# CONSERVATION COMMISSION DETAILED AGENDA

Date: January 26, 2023

#### 1. 14 Cedar Lake Drive – NOI – Construction of a Garage – DEP File #300-1151

- 2. **505 Main Street – NOI – Demo of a commercial building, replace with a multi-family residential building with associated parking – DEP File #300-1152**

**CONSERVATION COMMISSION PLAN**

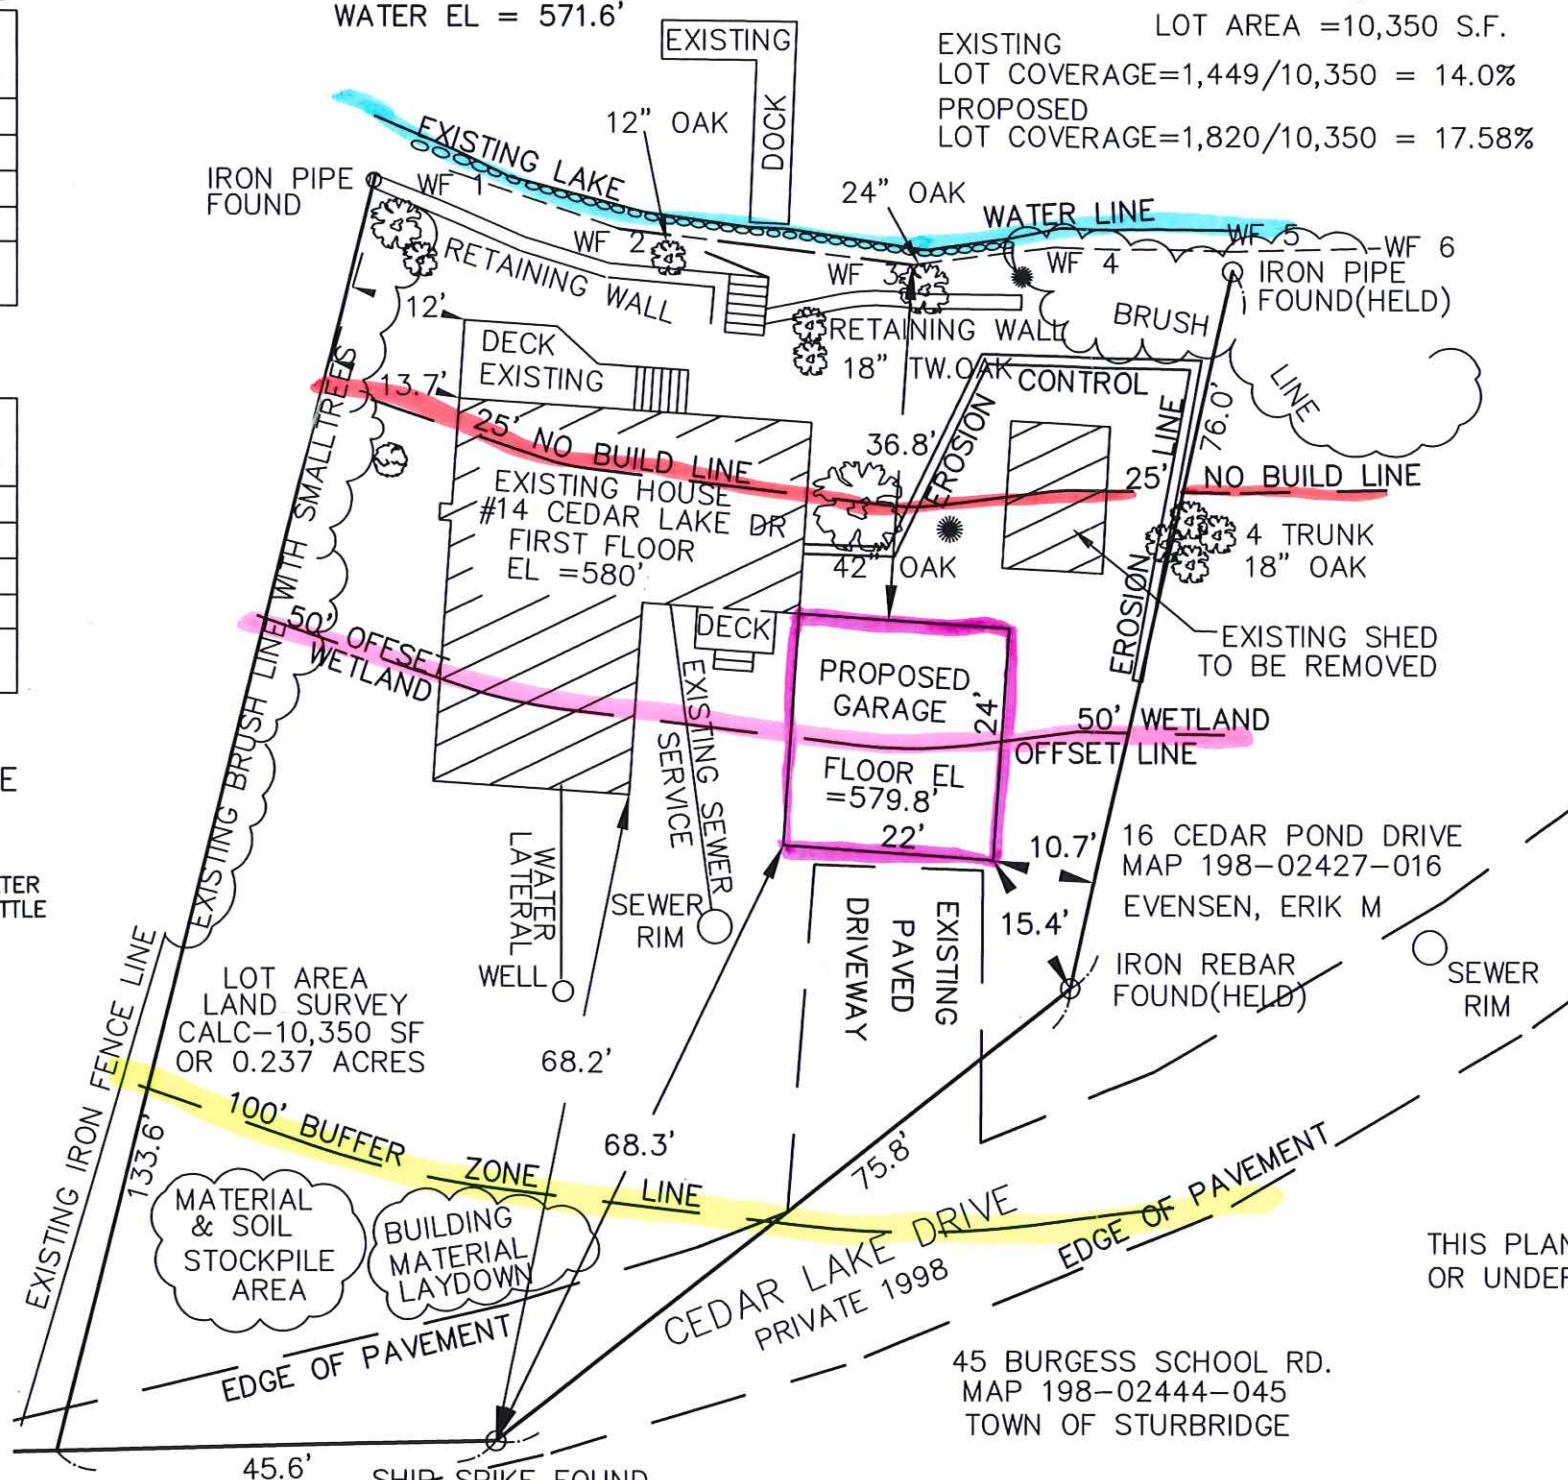
- Project site is not located within Priority & Estimated Habitat.
    - Site visit performed.
    - Project is within the buffer zone (BZ) to Bank. Property contains Bordering Land Subject to Flooding (BLSF) shown as Zone AE on FEMA Maps. MAHWL noted on plan as 575.2'. This elevation needs to be shown on the plan to ensure structure is not within BLSF and flood zone for building department.

- The proposed garage is outside the 25-ft buffer but within the 50-ft.
    - They will be removing a shed located closer to the lake and note restoring that area.

- They are providing rain barrels for roof runoff collection.
    - Application includes review of alternate locations. Zoning setbacks and the locations of the well & sewer line limits locations. Does not appear that the structure could be cited to be located outside of the setback, however, it may be able to shift further from the resource areas.

- Excavation is required for the footing and frost protection. Excavation would appear to impact tree roots of 42" oak near house. Tree would need to be removed. It is a large oak that has signs of decline.

- Applicant should explore if structure could be moved further out of the 50' BZ as discussed on site.
    - Waiver request needed to include mitigation. Applicant should explore shifting over part of the driveway and/or revise the project to include removal of the tree and include replacements. Appears could lose part of driveway and still park 2 cars. Will add encroachment to front setback but may be acceptable to zoning as consistent with adjacent properties. Should be explored.

- Staff Recommendations: Continue to next meeting to revise plan to show elevations, explore options to reduce BZ impacts & to demonstrate that waiver standards can be met. Next meeting is Feb 16<sup>th</sup>.

**SITE DEMO & SEDIMENT AND EROSION CONTROL PLAN**  
 MULTI-FAMILY RESIDENTIAL PROJECT  
 505 MAIN STREET, STURBRIDGE, MA 01518

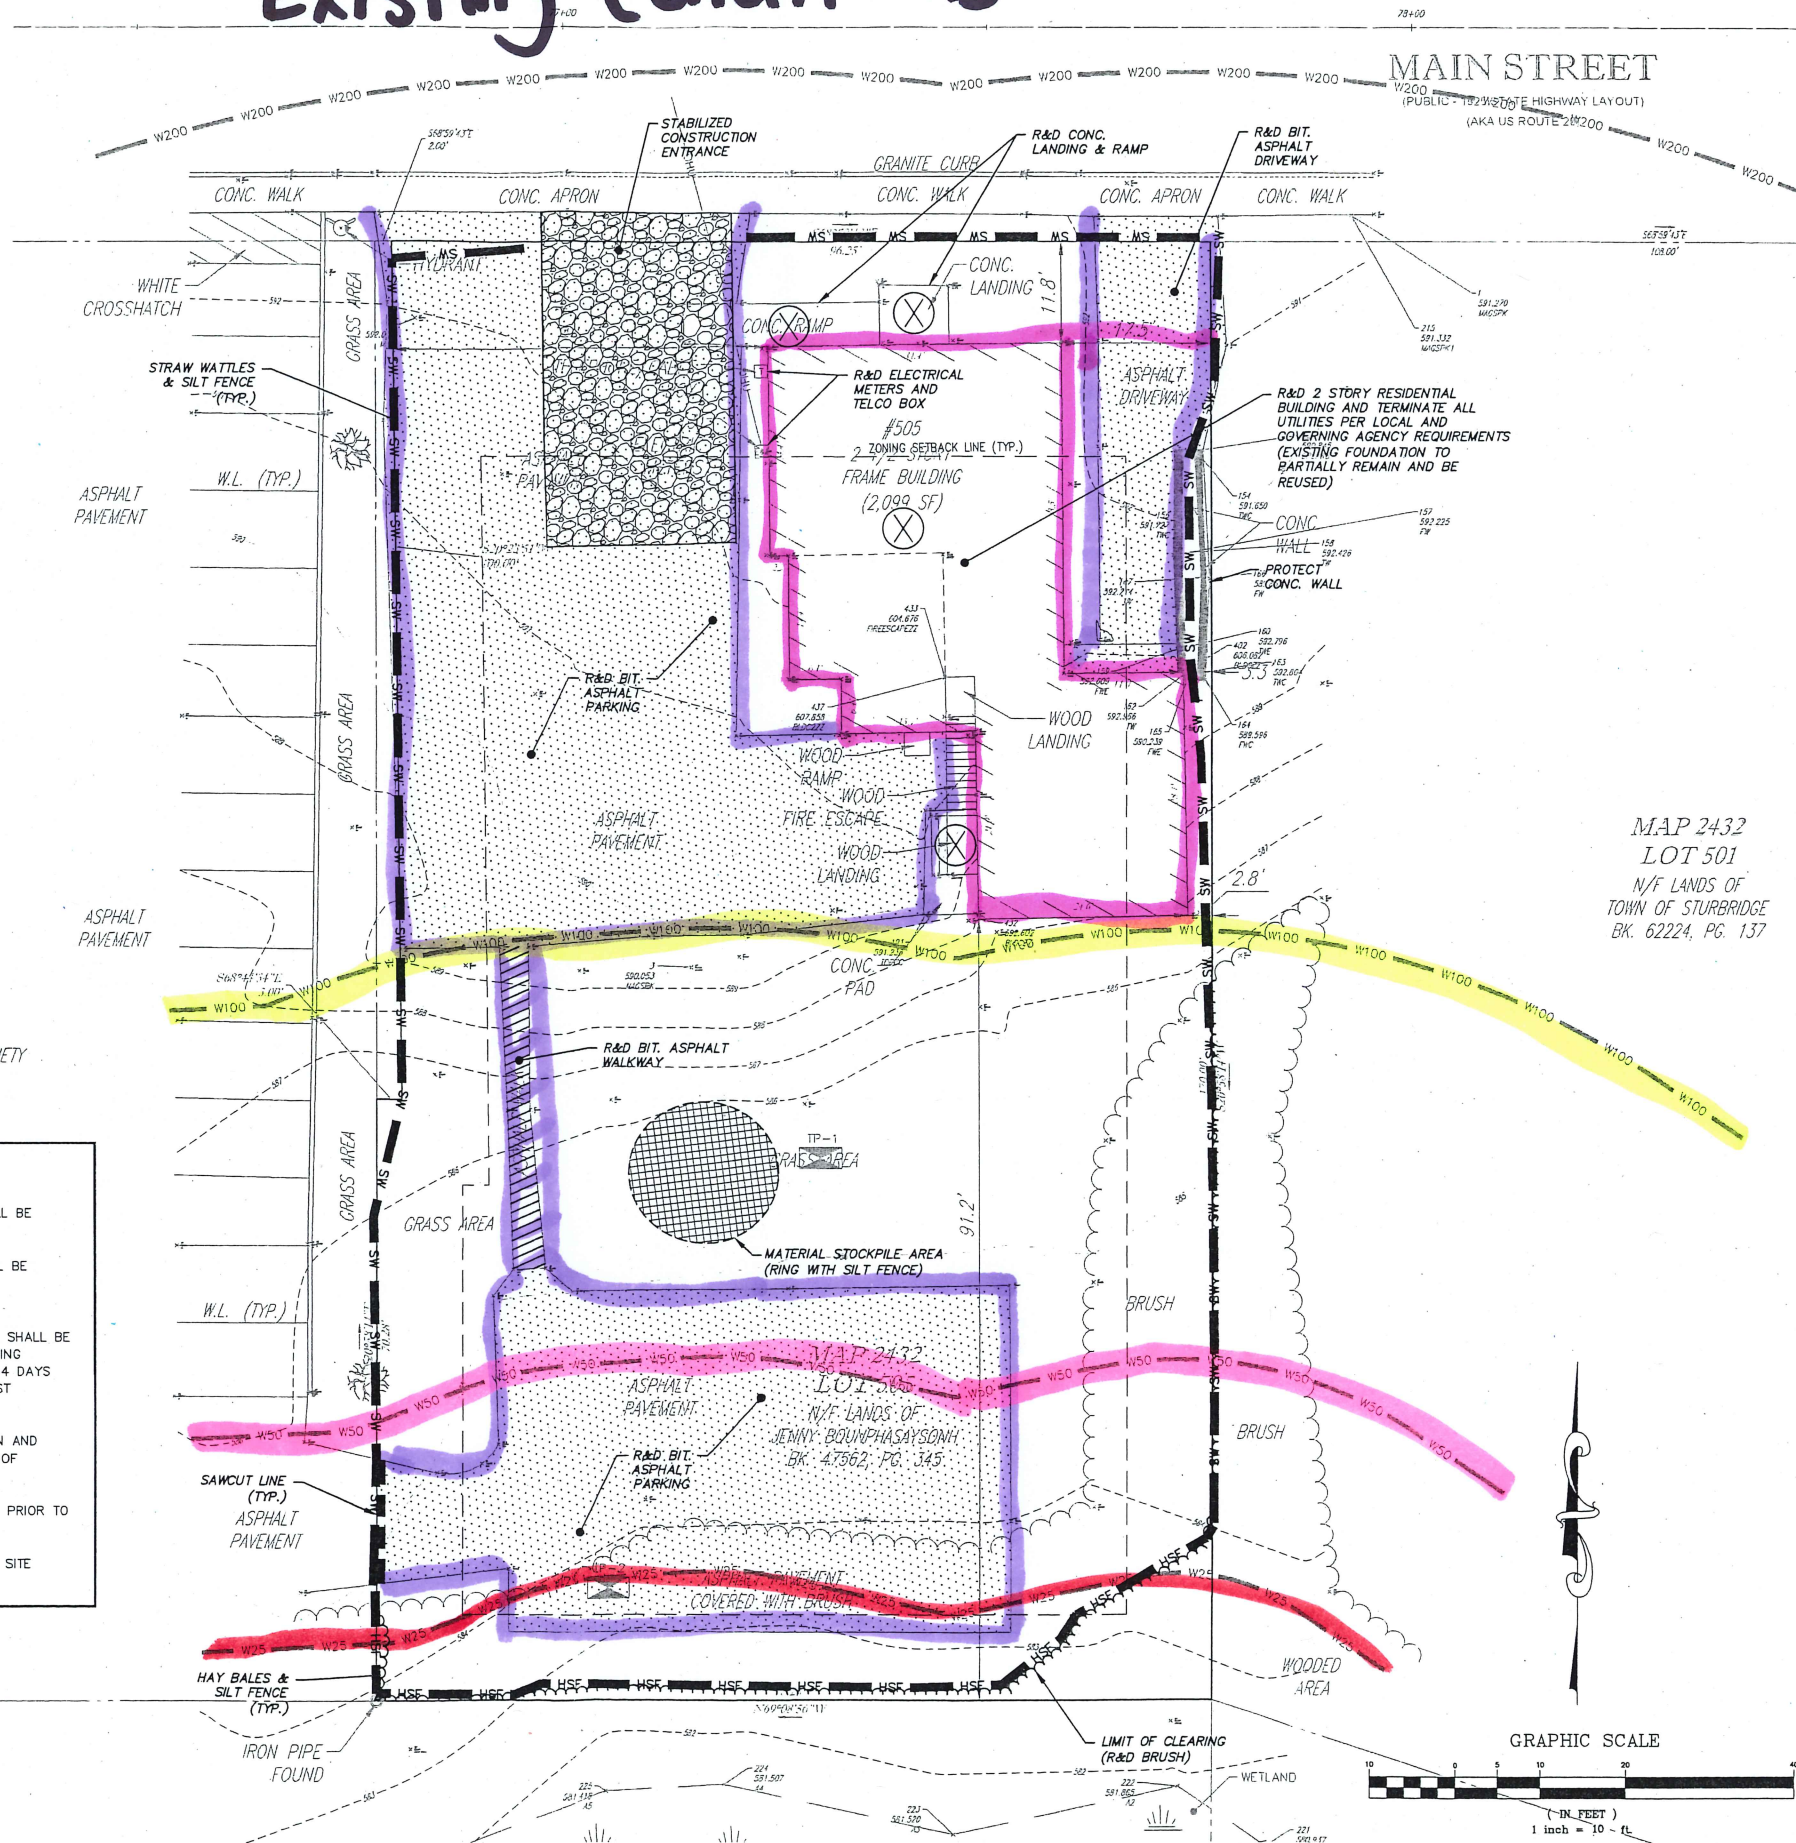
- Plan shows asphalt pavement covered with brush. This area has a significant amount of Japanese knotweed growing within it. It would appear that the pavement is substantially compromised as it is heavily vegetated. The proper removal of the invasive would be recommended.

## GRADING & DRAINAGE PLAN MULTI-FAMILY RESIDENTIAL PROJECT 505 MAIN STREET, STURBRIDGE, MA 01518

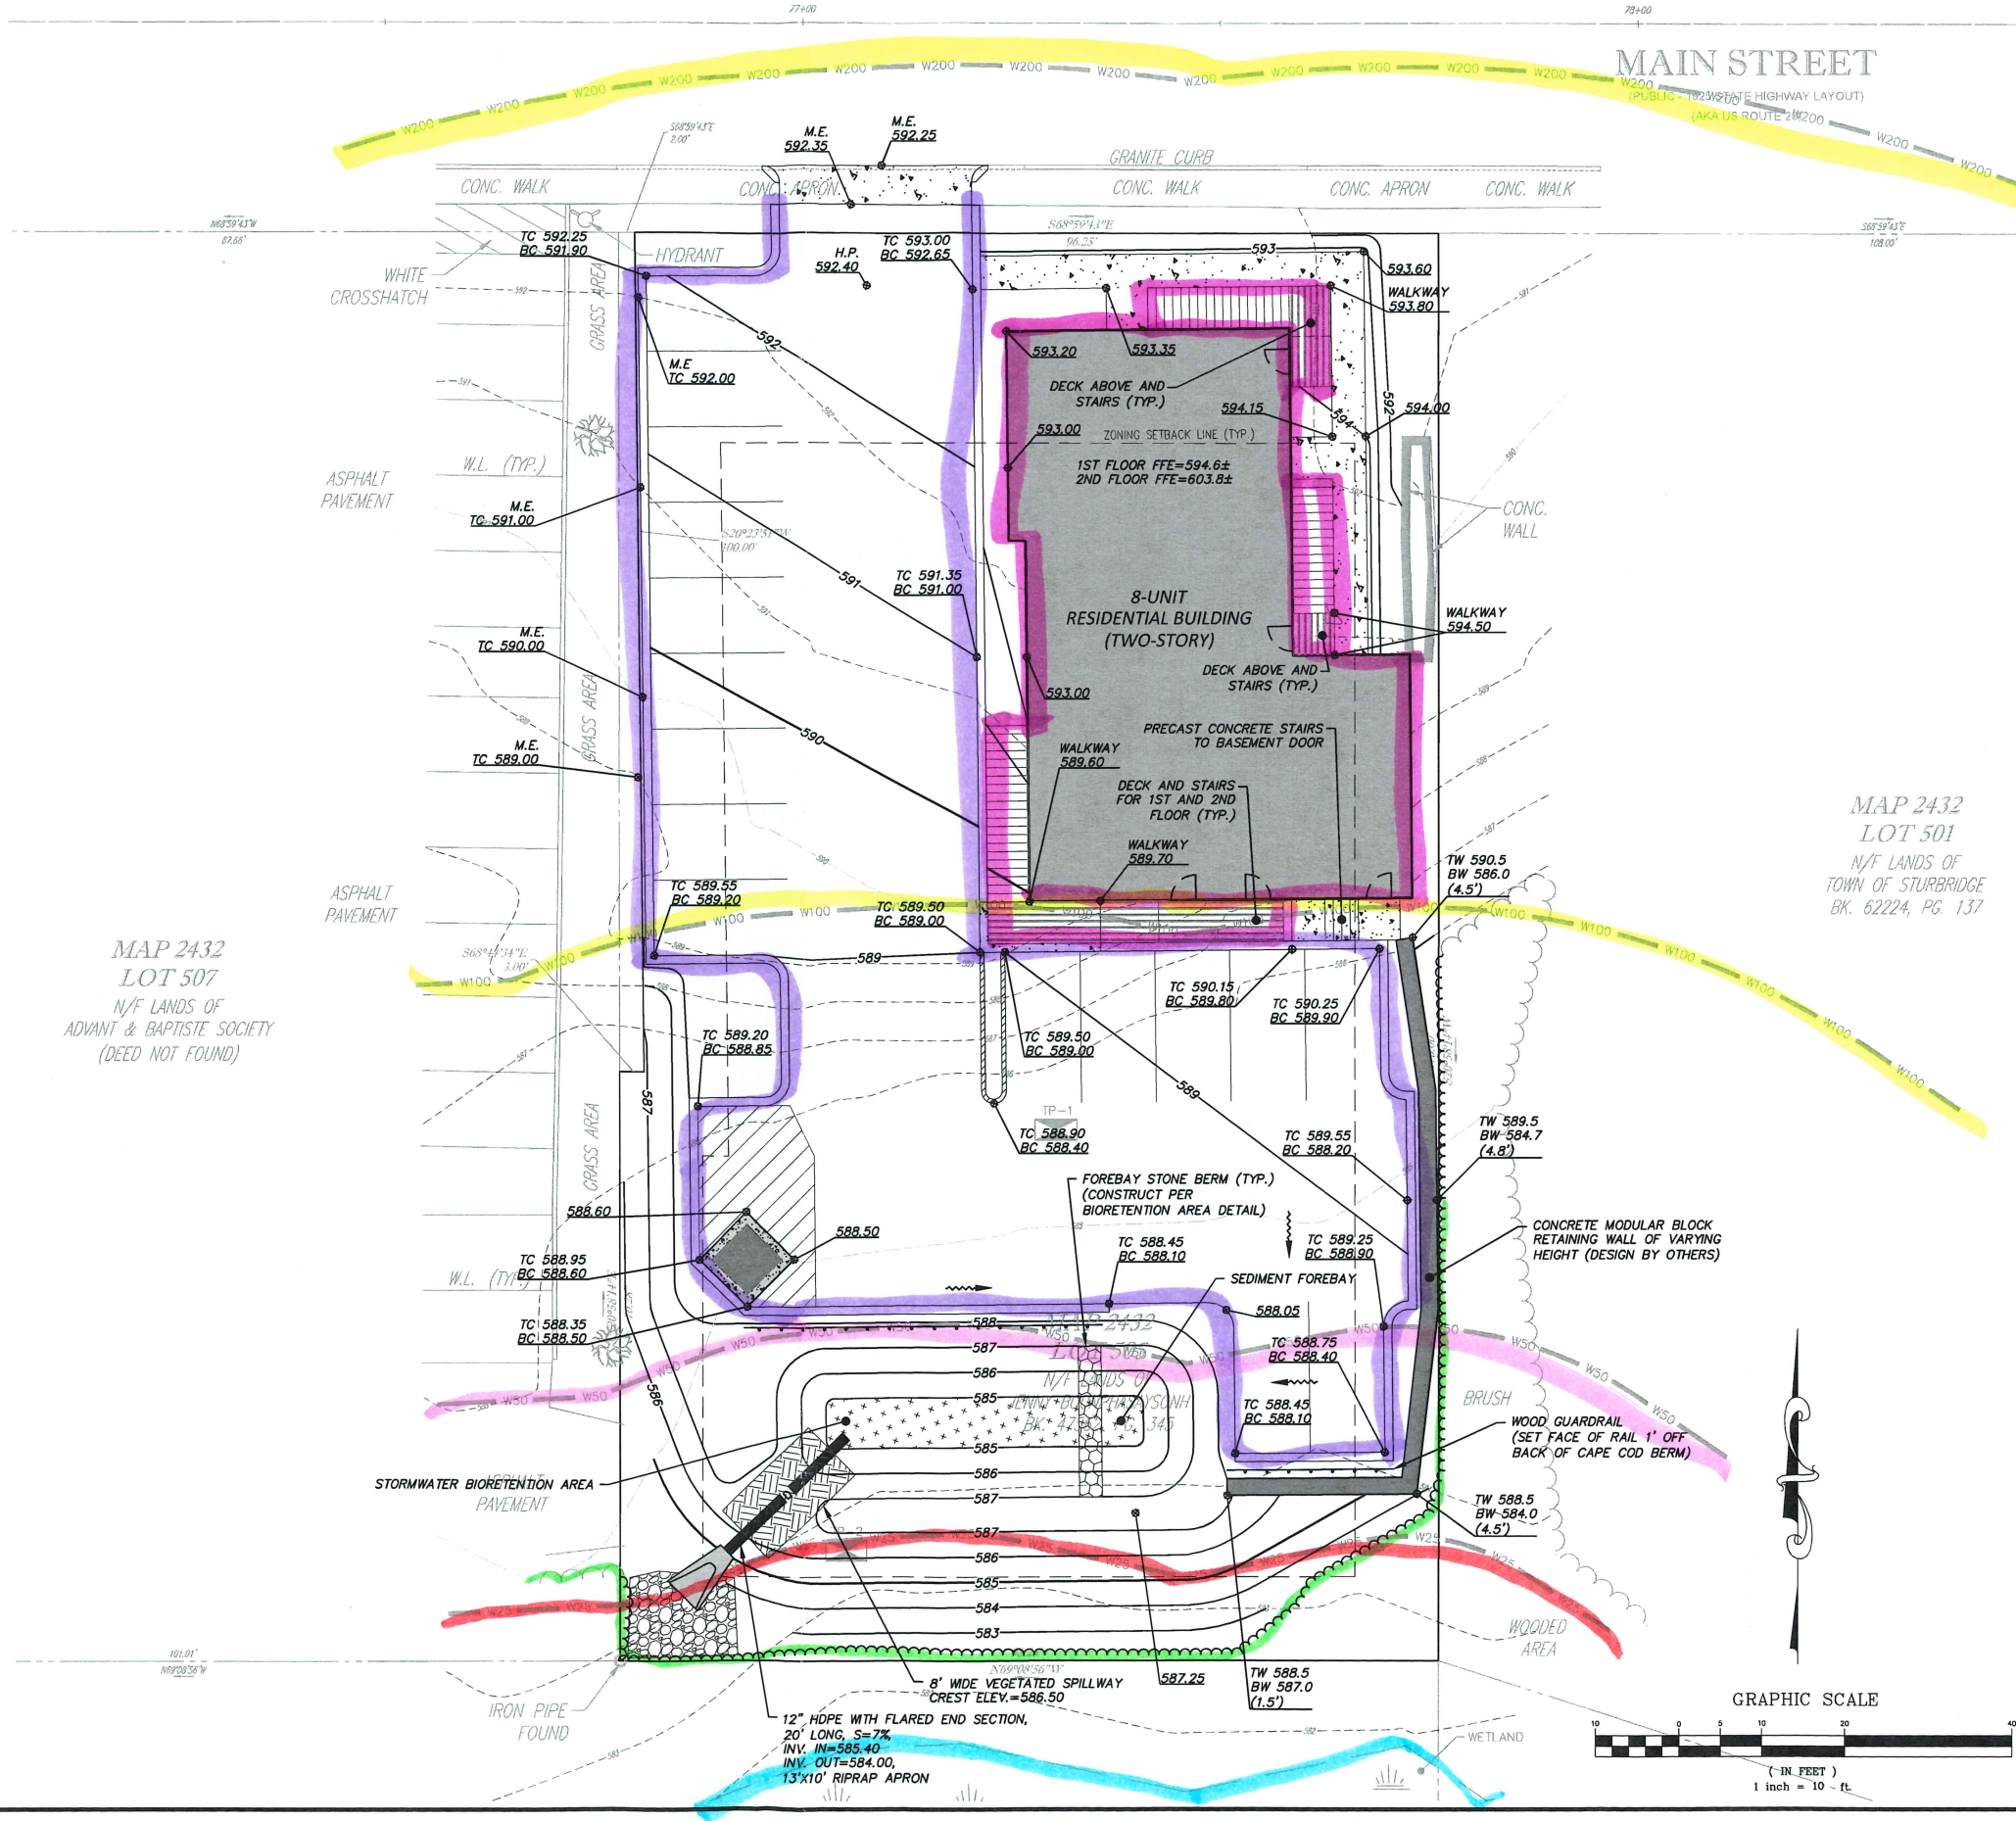
- As project includes an increase of impervious surface, the project is considered a new project per MA Stormwater Standards. A peer review for stormwater compliance is needed by a P.E. Staff are pleased to see the use of the bioretention basin for stormwater management. Does the stormwater system include runoff compensation for the entire lot (roof and impervious walkways)? It does not appear that any green space remains on lot outside of the restoration area on the stormwater basin slope.

- Project includes new impervious surface within the 50’ no new structure setback. Per Bylaw Regs definitions a structure includes: “Any man-made or man-assembled impervious or partially impervious combination of materials and includes but is not limited to buildings, asphalt driveways, retaining walls, patios, swimming pools, sheds (decks, porches), framework, or any part thereof existing on, above or below the level of land or water.”

- Project also includes work within the 25’ no disturb to include the side slopes of bioretention basin and basin outlet and splash pad within feet of the wetland. LOW shown at 11’ closest to wetland.

- Project does include buffer restoration area, however, it is all within areas needed for grading associated with the side slope of the stromwater basin. O & M Plan should include no mow area for restoration area.

- The applicant should clarify the extent of grading which would appear required in order to remove slope in between the existing building and rear parking area. Also appears fill required for basin and back parking area. All of this is within the 25 and 50’ setback. No change of grading shown in the rear parking rea. Modular block wall proposed along the side of parking lot. Appears there will be a grade change proposed here. There is a sloped lawn area here currently.

- Project isn't in compliance with local setbacks. Alternatives must be explored. It would appear that there is an opportunity here to redevelop this site and provide wetland setbacks. The new building will be larger and noted as 8 units that is an expansion which results in the increase of impervious surfaces on the property and need to work within 11' of the wetland. A reduction of units would minimize parking needs and allow for greater setbacks. It would also appear to assist with conformance w/ zoning setbacks if the building envelope was then modified. Removal of impervious in the rear of the building would allow for a modified stormwater basin design which would provide a greater setback from the wetland.

- Staff Recommendations: Staff recommend voting to require the peer review for stormwater. Continue hearing to allow applicant time to address items listed above & to receive peer review proposals. Continue to the next meeting: Feb. 16<sup>th</sup>.
